SERIAL: BSEP 02-0174  
TSC-2002-10

SUBJECT: Brunswick Steam Electric Plant, Unit No. 2  
Docket No. 50-324/License No. DPR-62  
Request For License Amendment Regarding  
Technical Specification 2.1.1.2, Reactor Core Safety Limits  
Minimum Critical Power Ratio Safety Limit

## Evaluation of Proposed License Amendment Request

Subject: Technical Specification 2.1.1.2, Reactor Core Safety Limits  
Minimum Critical Power Ratio Safety Limit

Figure 1 Reference Core Loading Pattern – Cycle 15

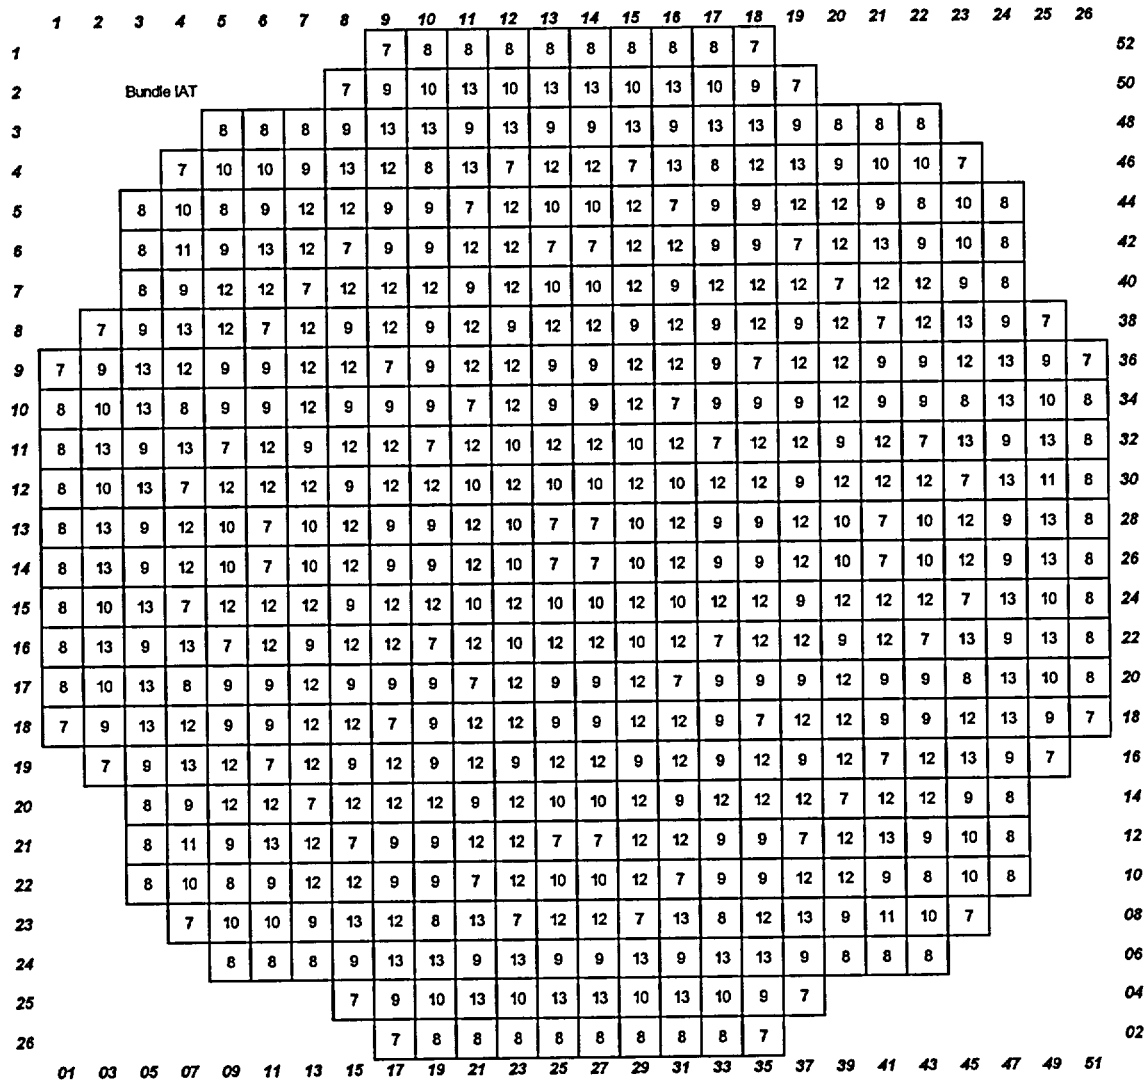
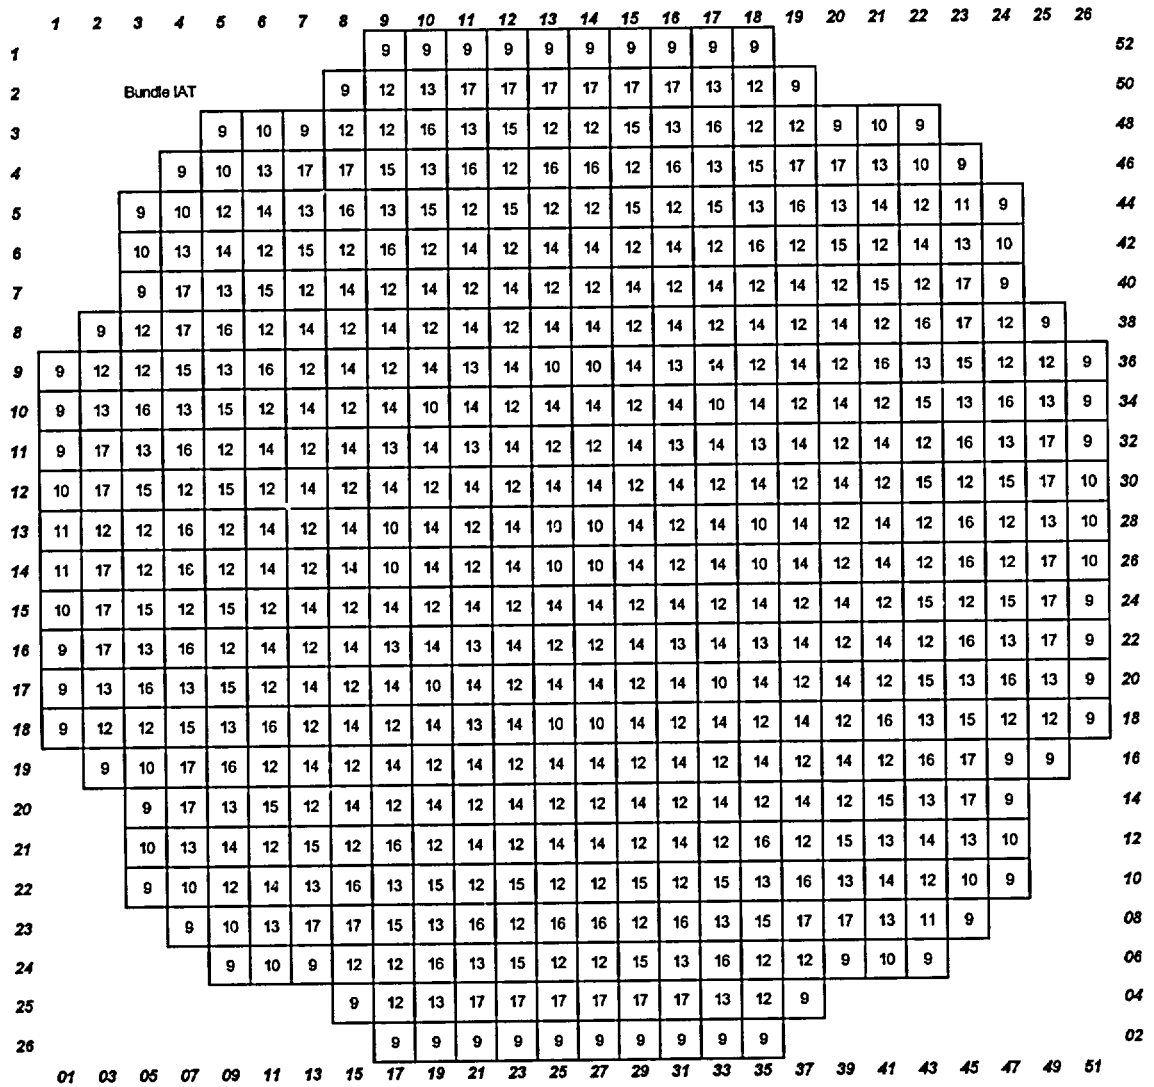
The core loading information for Brunswick Unit 2 Cycles 15 and 16 is provided in Figures 1 and 2, respectively. The impact of the fuel loading pattern differences on the calculated SLMCPR is correlated to the values of [[ ]]
